County Plan No.: S-127-93
 Project Name: GOV LAND - MARINA VILLAGE BMP #2 (AT MARINA LOT PARKING)
 Stormwater Management Facility: WET MARSH

Project Name: GOVERNOR'S LAND AT TWO RIVERS - THE HARBOR AT TWO RIVERS
Structure/BMP Name: HARBOR BMP
Project Location: SOUTH OF INTERSECTION OF HARBOR ROAD & RIVER OAKS ROAD
BMP Location: SOUTH OF HARBOR PARKING AREA
County Plan No.: S - 127 - 93

Re: Governor's Land - Marina Village
County Plan No. S-127-93
Stormwater Management Facility
County BMP ID Code: JR 032

DRAINAGE AND EROSION CONTROL PLAN
THE HARBOR • TWO RIVERS
GOVERNOR'S LAND
AT
TWO RIVERS
JAMES CITY COUNTY
POWhatan DISTRICT

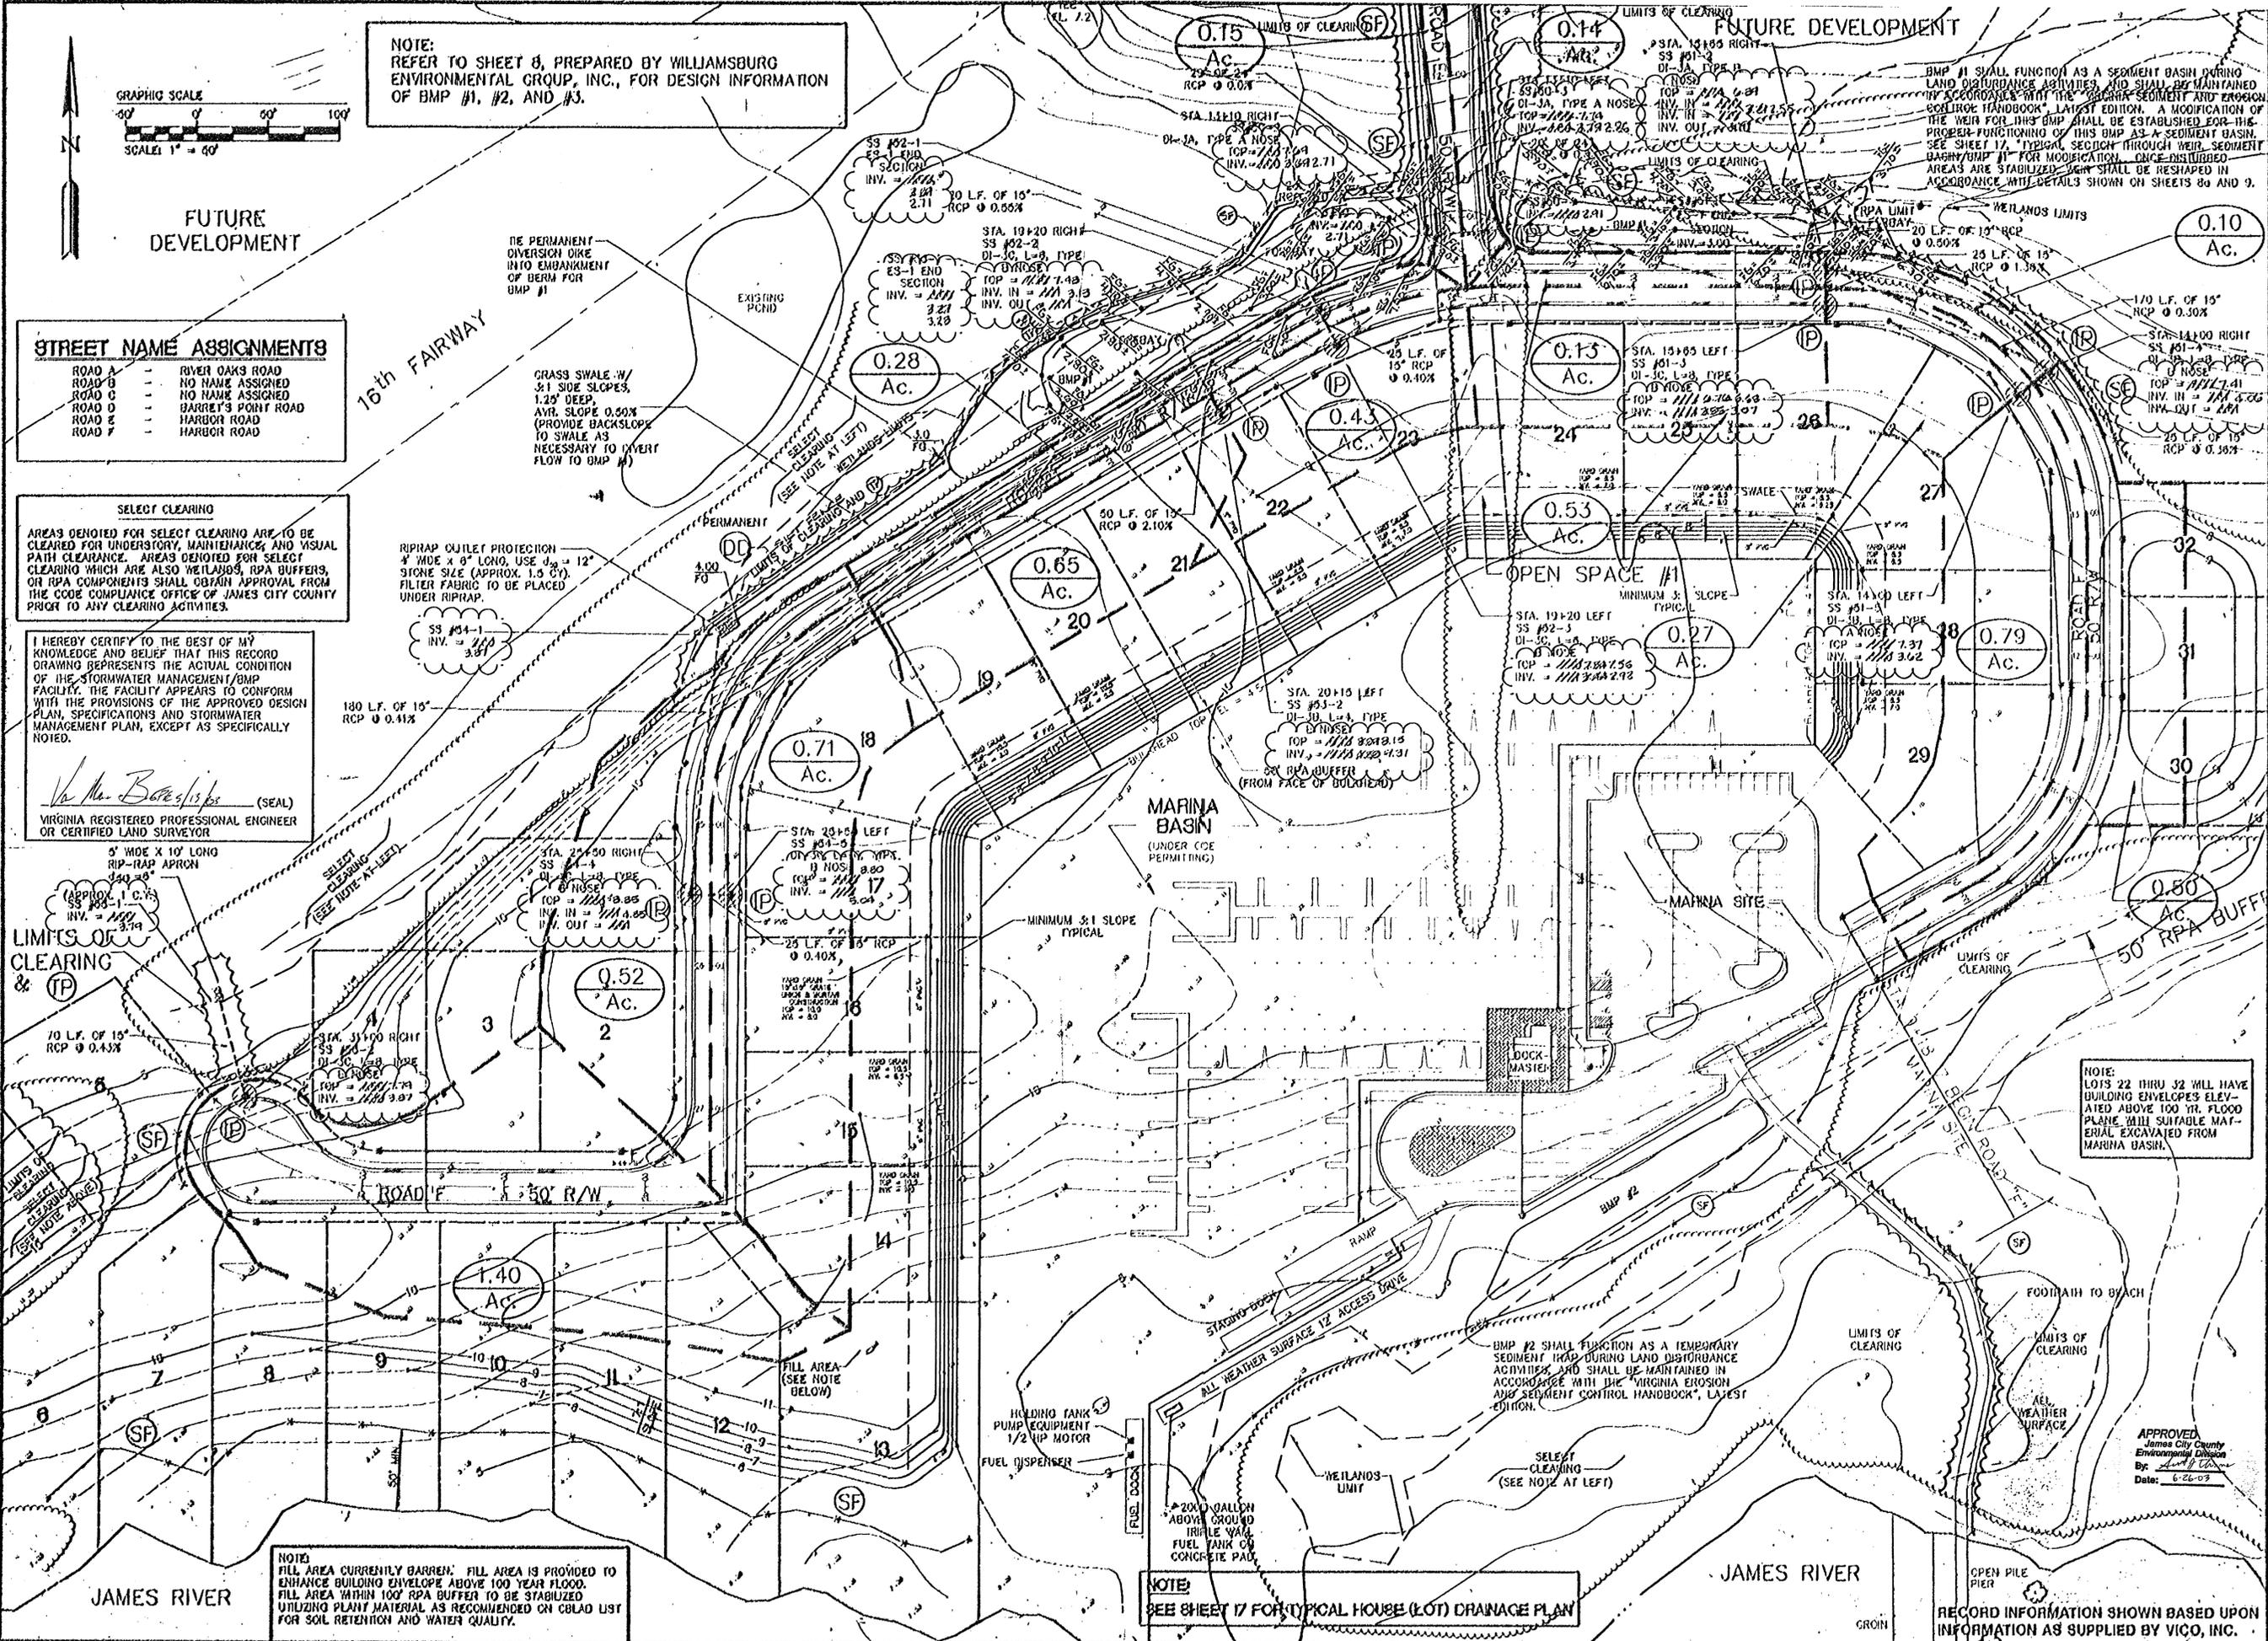
1. Based on a review of the plans and active file for the project, there appears to be no construction certification requirement imposed for this BMP.

2. The record drawing dated June 7th 1999, with a certification date of March 30th 2002, is **satisfactory**. Please forward one reproducible and one blue/black line set of the record drawings to our office.
